SB Number:	SB 2FZ-029	Creation Date: 12/06/2008
Subject:	Add protection sheet to prevent scraping of the fuser heat roller	
Model:	KM-C2520/3225/3232/2525E/3232E/4035E

Sectional drawing of the heat roller on the fuser unit/thermostat section

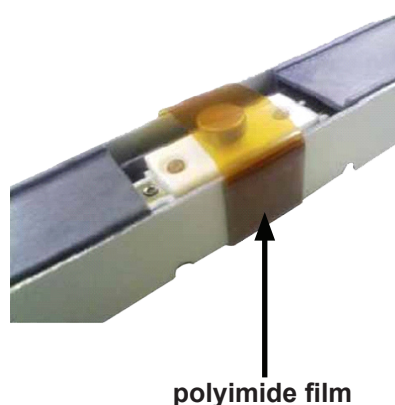
Phenomenon	Depending on the wiring process of the fuser thermostat wire, it may be possible that the fuser thermostat scrapes against the surface of the heat roller.
-------------------	--

Solution	Add polyimide film on the surface of the fuser thermostat between the thermostat and fuser heat roller, to protect the heat roller.
-----------------	---

Field measure	When the above mentioned phenomenon occurs, please replace the fuser unit with the new model.
----------------------	---
